HARRIMAN
UTILITY
BOARD

SANITARY
SEWER LINE
RELOCATION

HARRIMAN UTILITY BOARD
FORCE MAIN INSTALLATION
BAUMGARDNER STREET TO BREEZEALE STREET

10" FORCE MAIN
RELOCATION

STA. 21+00.00 TO STA. 35+00.00
SCALE: 1"=50'

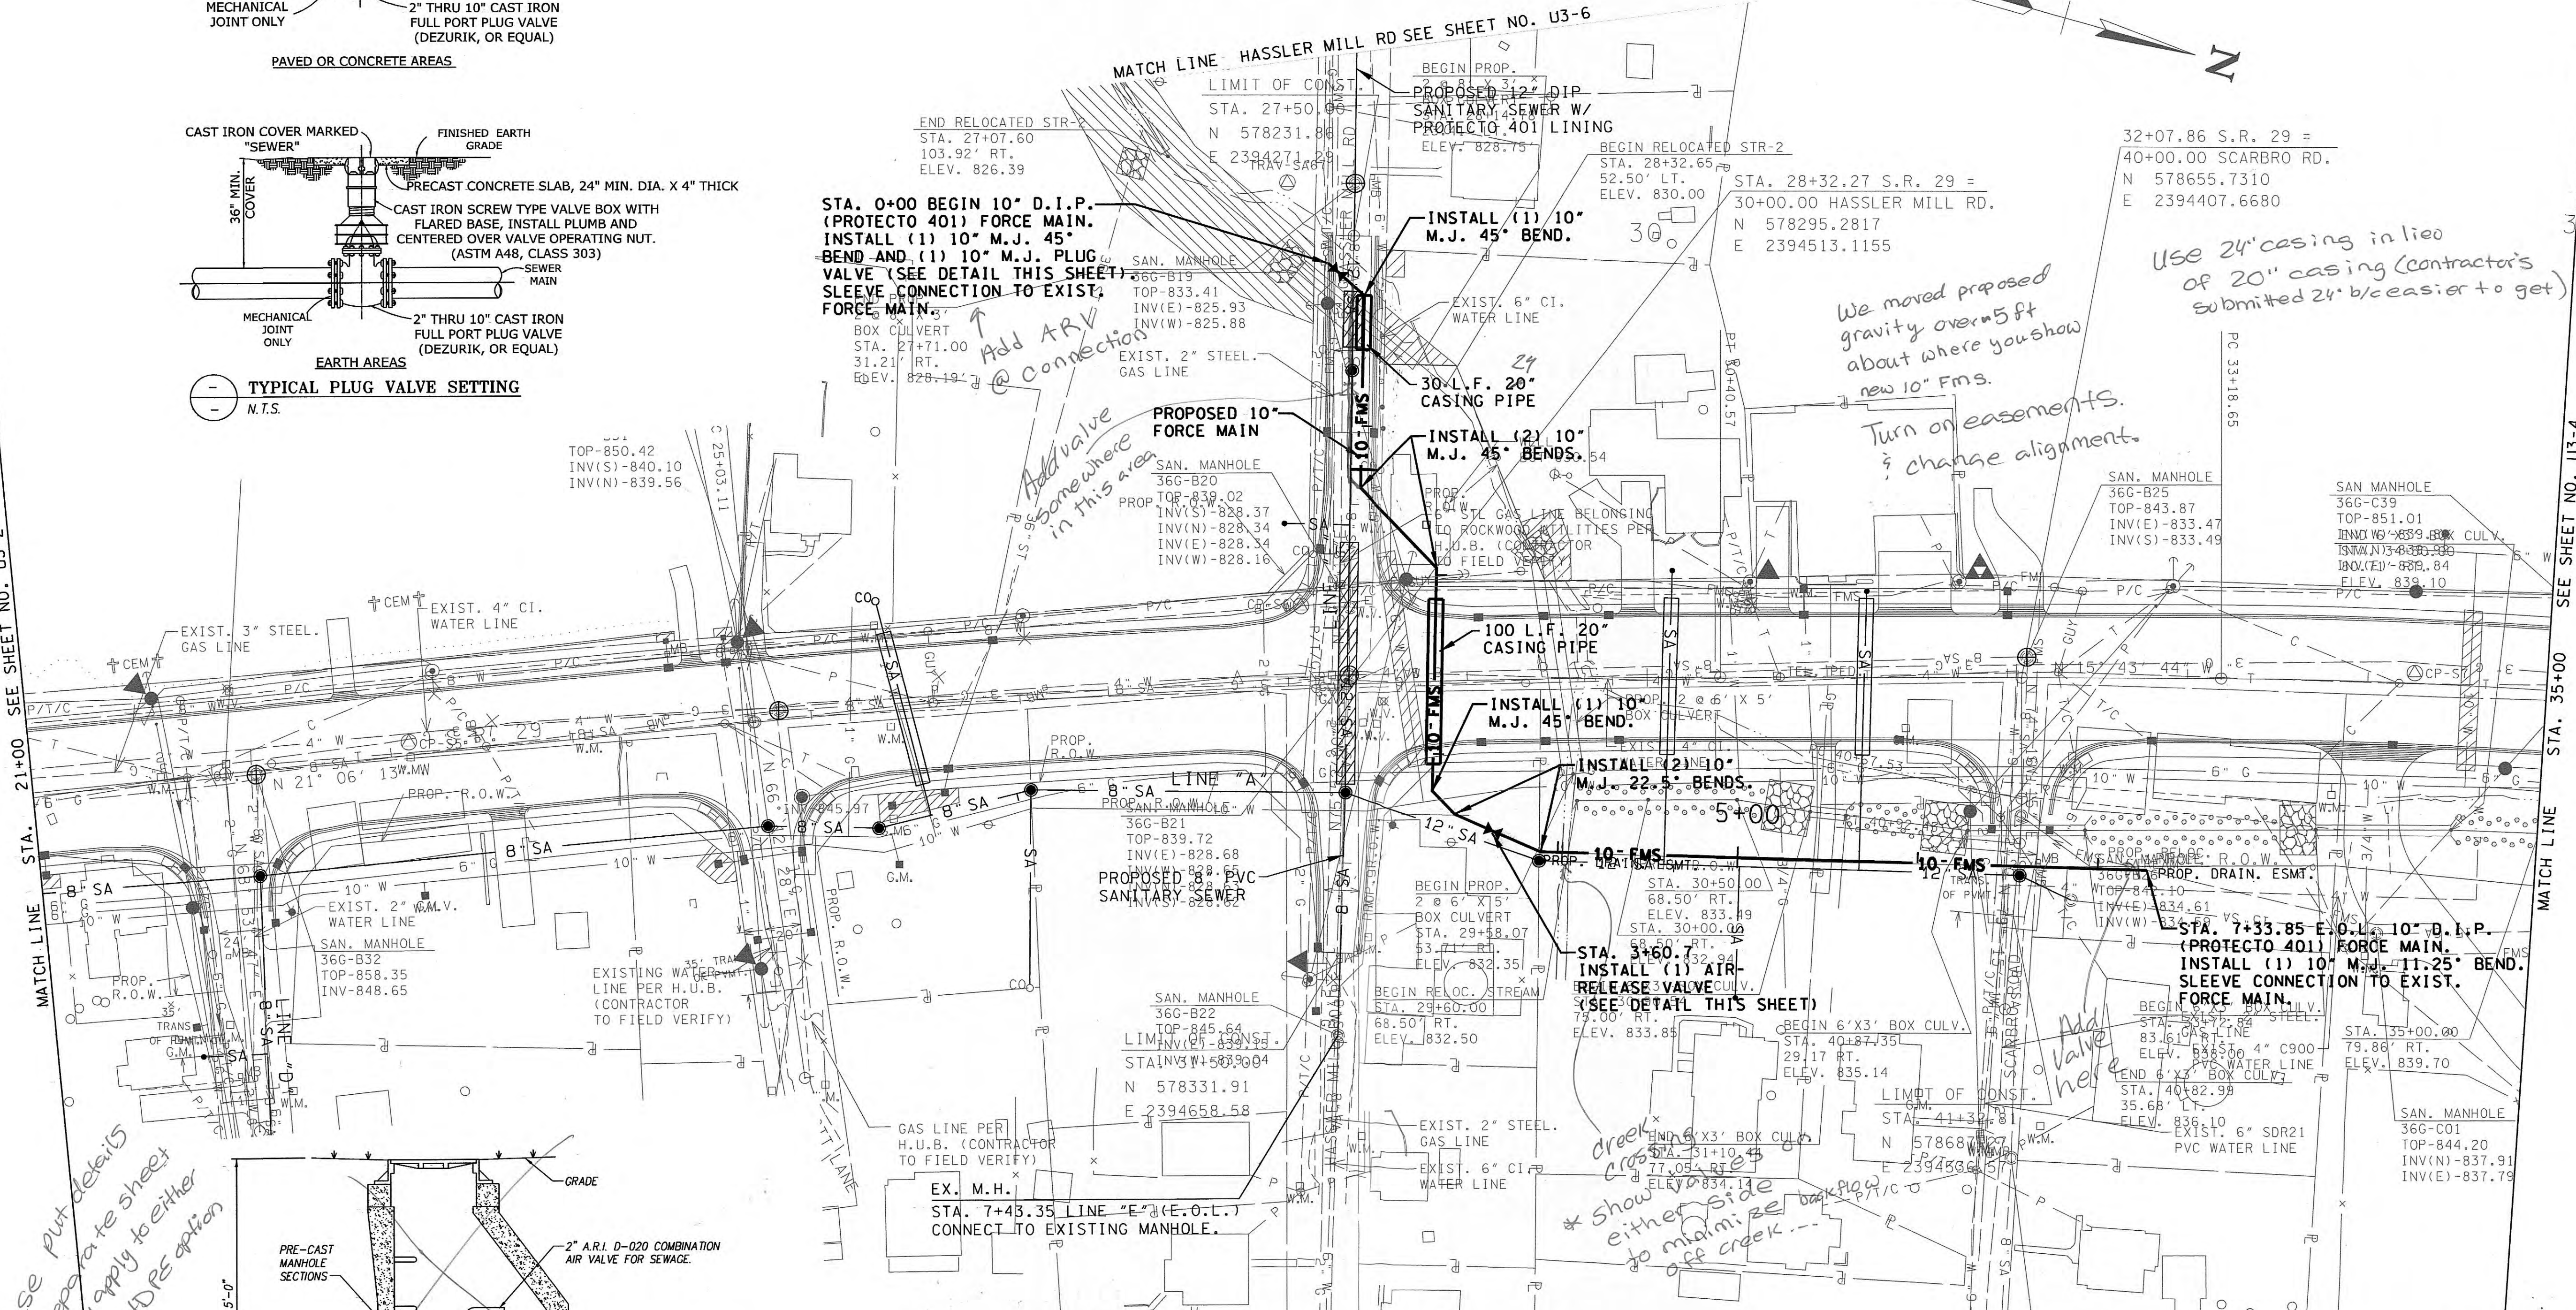
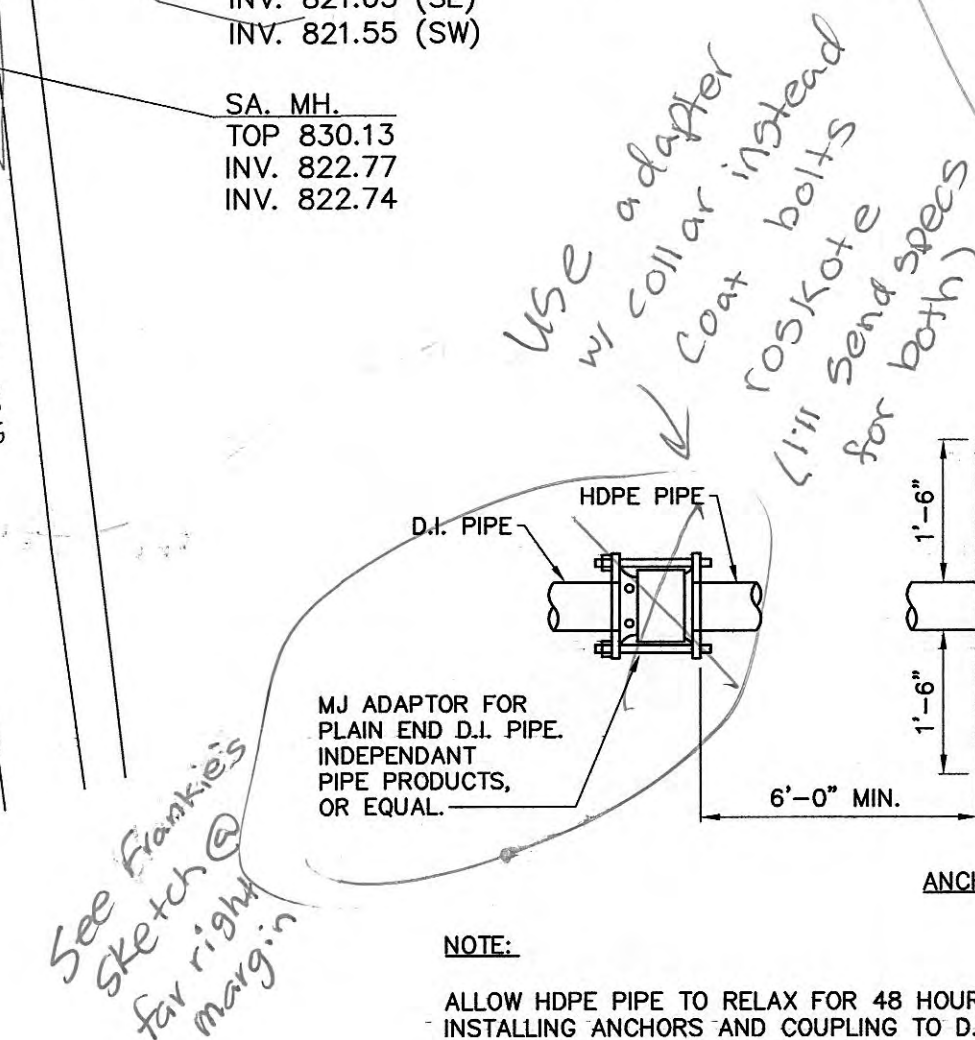
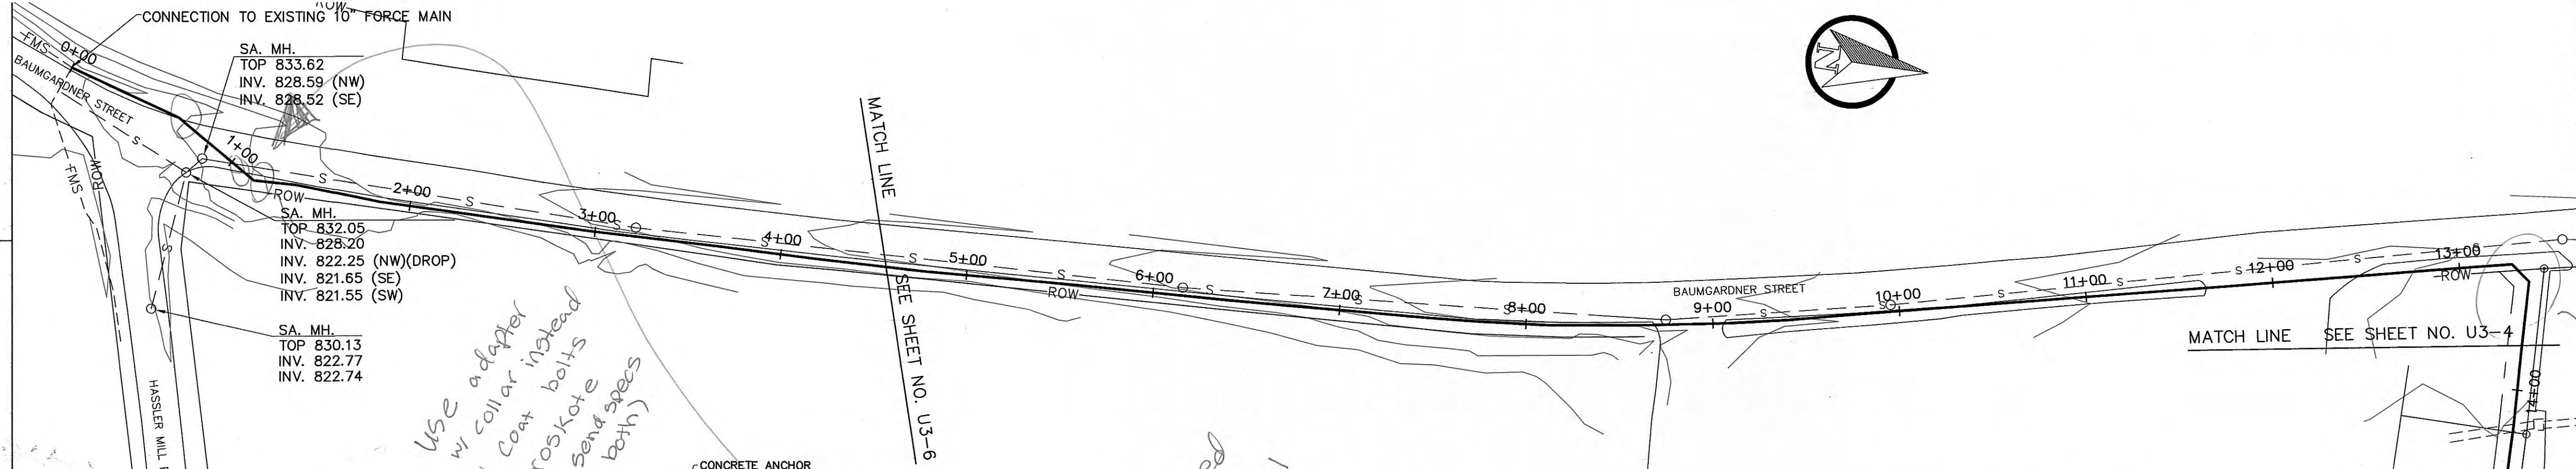
↑
We already have a
U3-10...

please put details
on separate sheet
so they apply to either
DIP or HDES option
See attached
detail

We moved proposed
gravity over 5 ft
about where you show
new 10" Fms.
Turn on easements.
& change alignment.

Use 24" casing in lieu
of 20" casing (contractor's
submitted 24" b/c easier to get)

* Show
either side
to minimize
off creek...

ANCHOR AND PIPE TRANSITION DETAIL
NOT TO SCALE

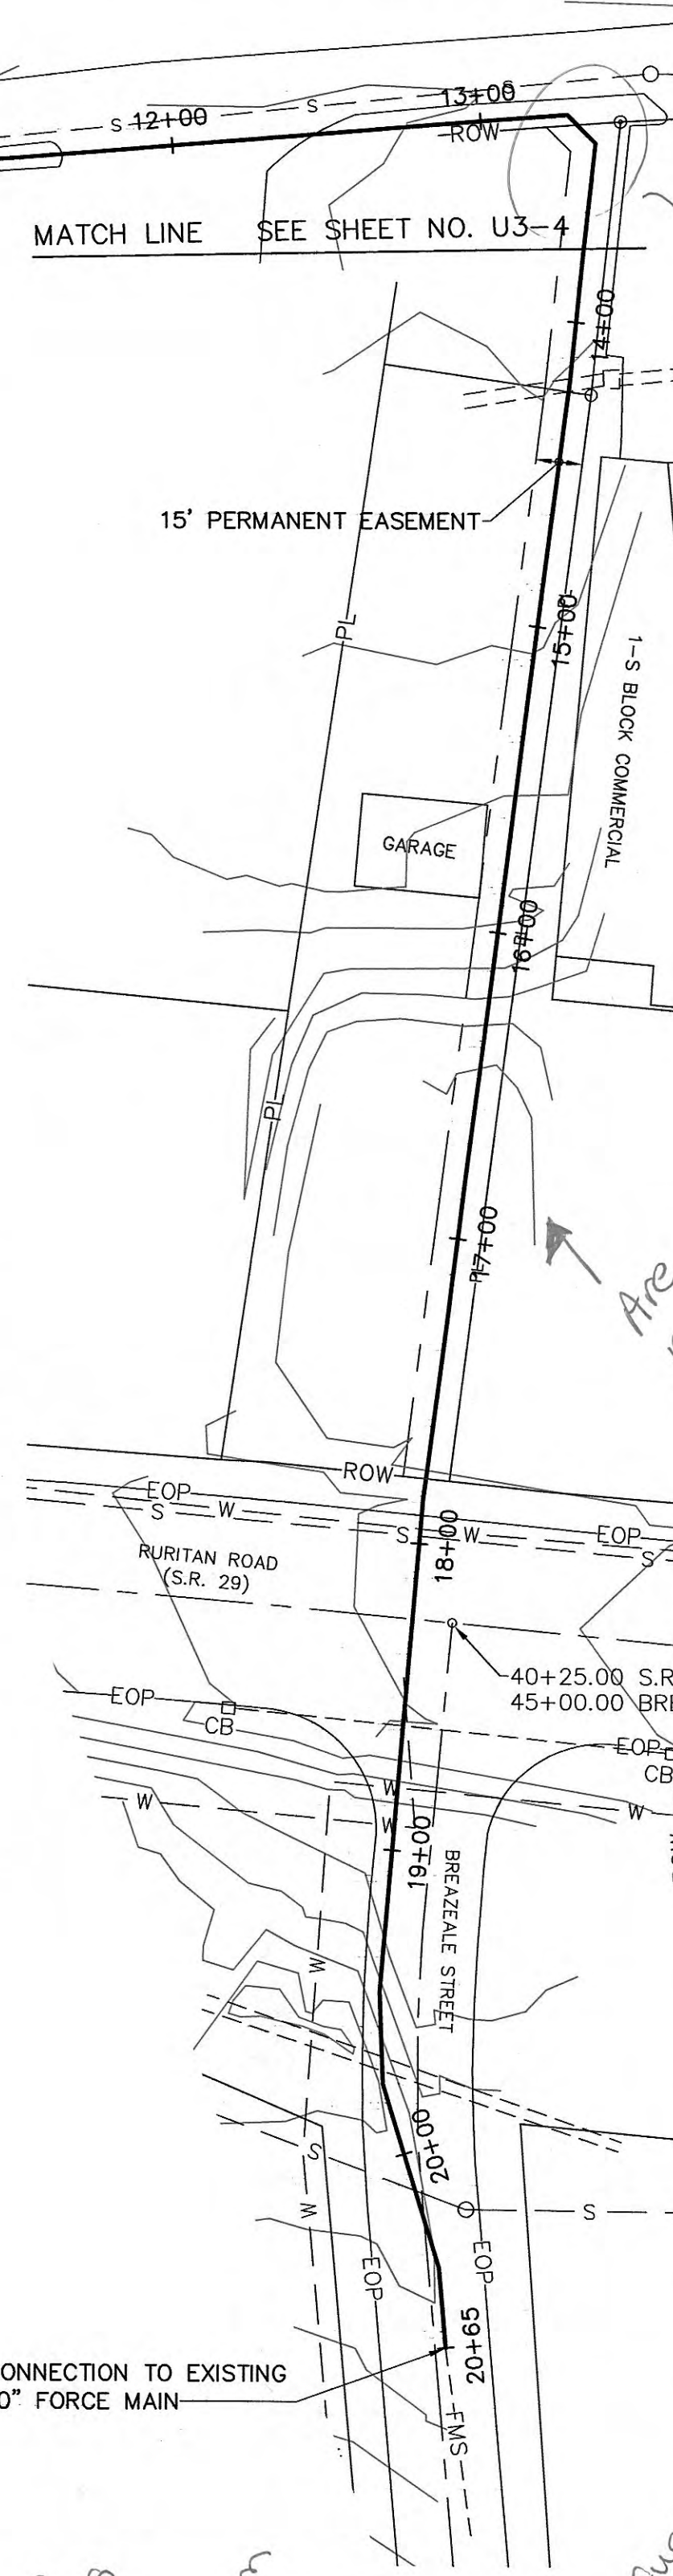
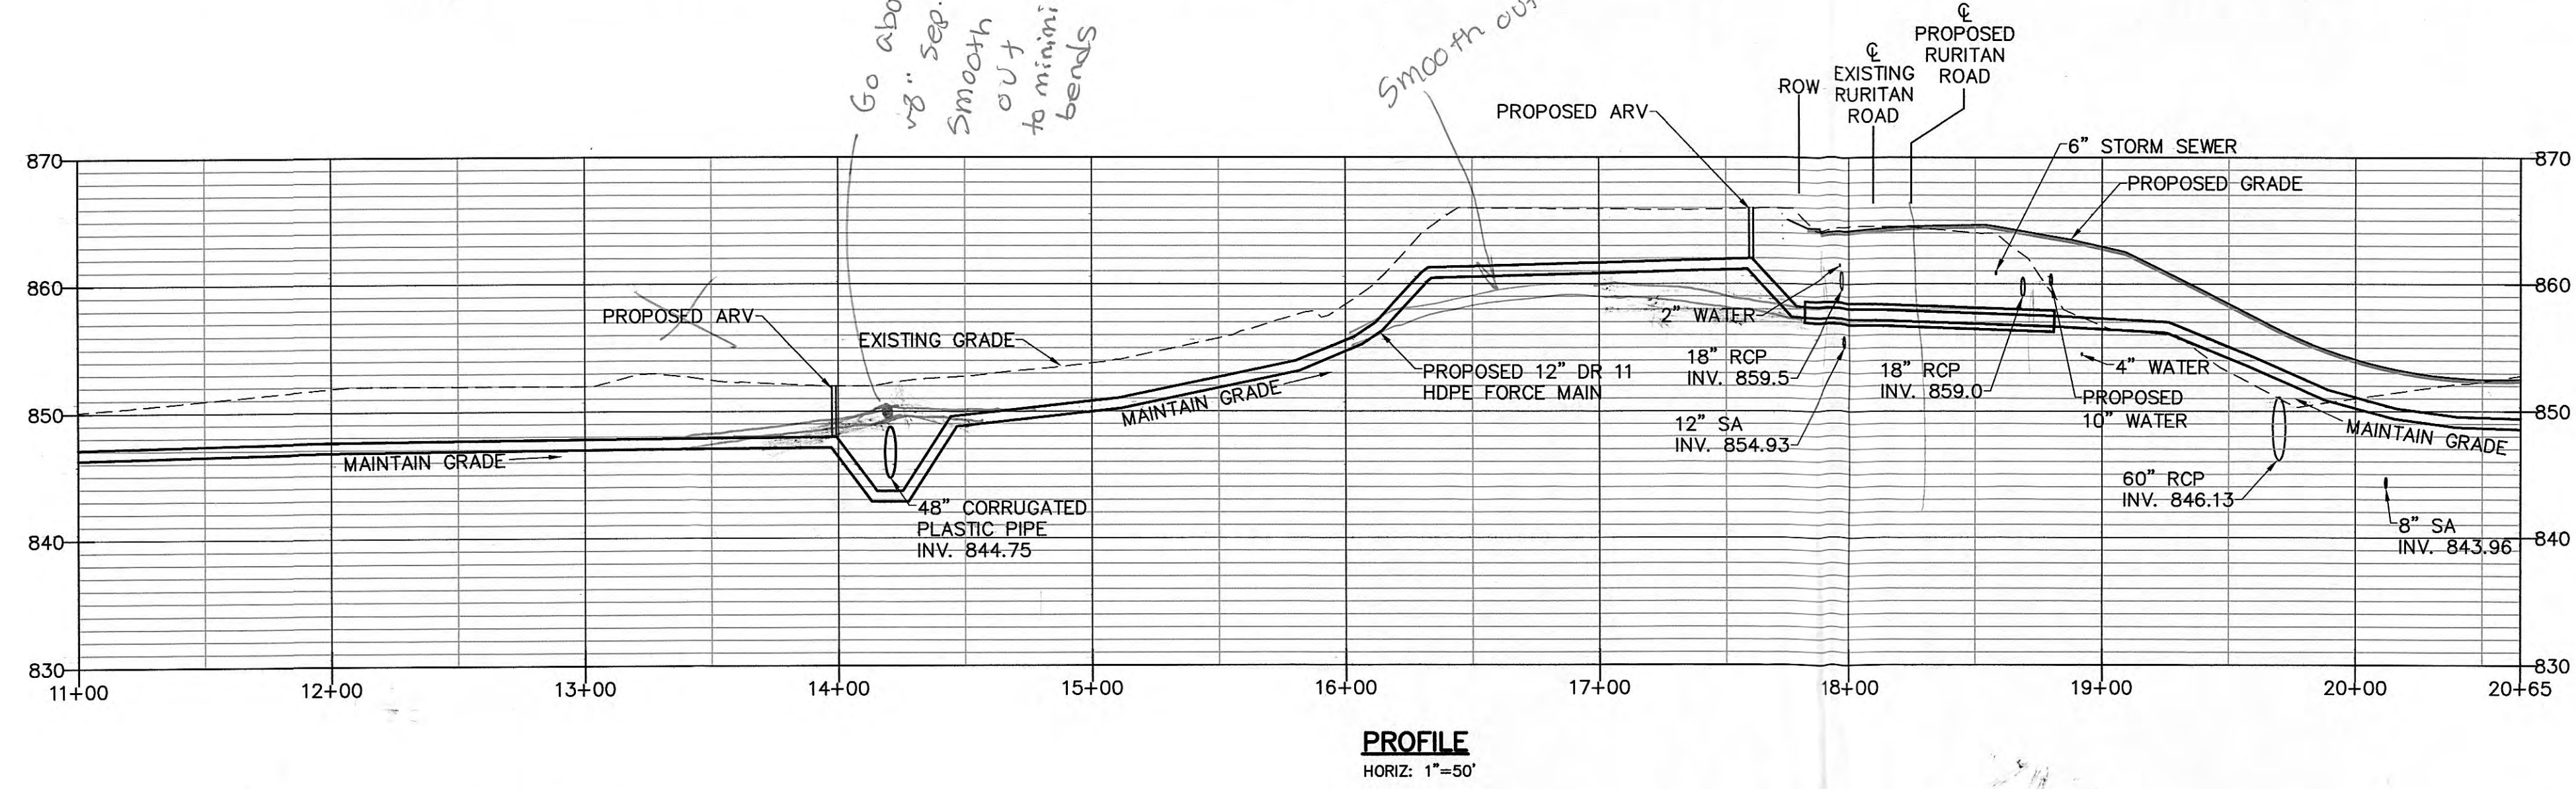
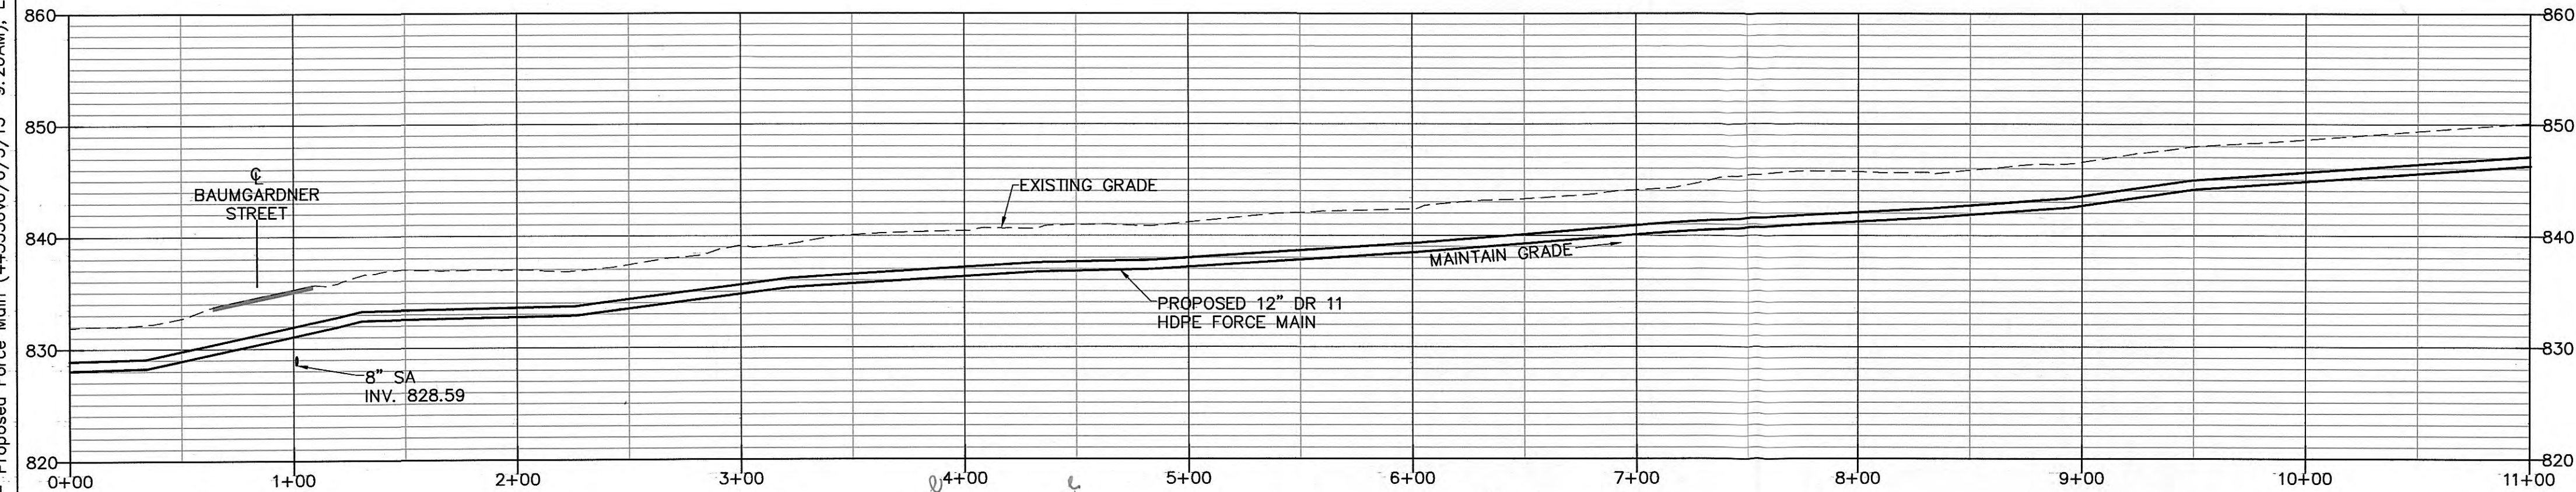
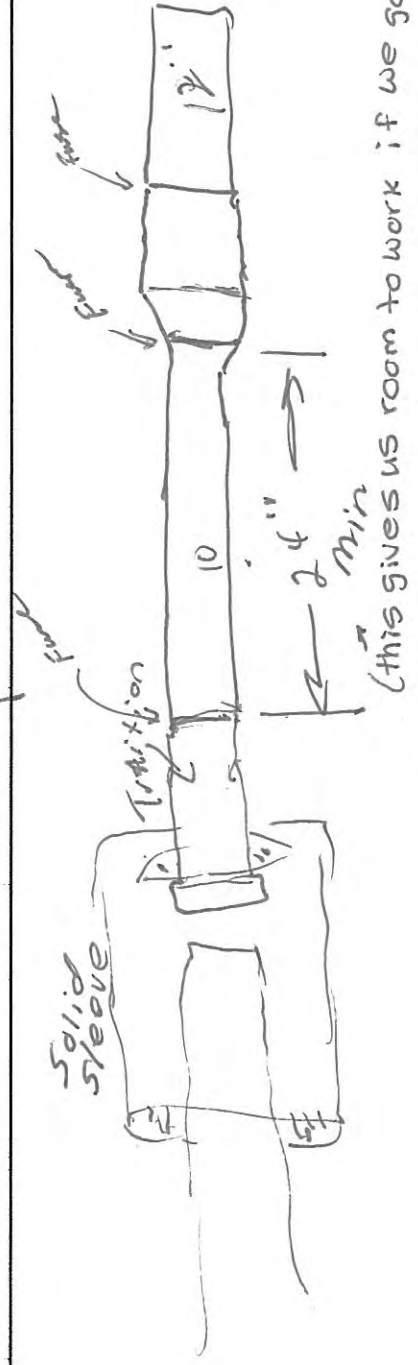
Do you need
any horizontal
fittings?
Can we smooth
out?

Call out
fittings.
